# Fire safety for a family home · early warning and safe exit · Taif / Palm House V7.1

Owner decision 1 Nov 2026 (design review E-08, critical) · the adopted scheme, its verification (§ 5) and the family escape plan (§ 6) · the rules cited; the Saudi 2024 texts are **not verified** here: the designer of record confirms them before the permit set

## How the net clear opening is counted

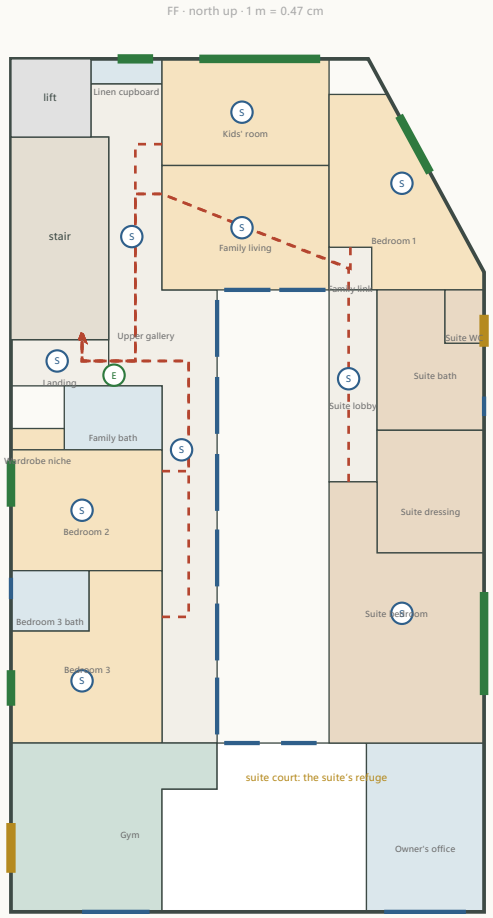
- The window line of the plans is the structural opening; black steel side-hung casements of ≤ 1.2 m, a 50 mm frame and sash edge all round, **one sash opening fully with one movement** (a single handle, no key, no restrictor). Net clear width = sash width − 2 × 0.05 height = (head − sill) − 2 × 0.05. Tilt-only, top-hung or sliding sashes do not count. **Engineer / window supplier to confirm** the sash sizes and the hardware on the shop drawings (**not verified** until then).

- The heights come from `3d/params.yaml` (the maid window listed at sill +1.10; the bedroom windows at the default sill 0.90 / head 2.10). The bedroom windows in the plans are 1.0–3.6 m wide: every one passes with one sash of ≤ 1.0 m, the maid window with its single 1.14 m sash.
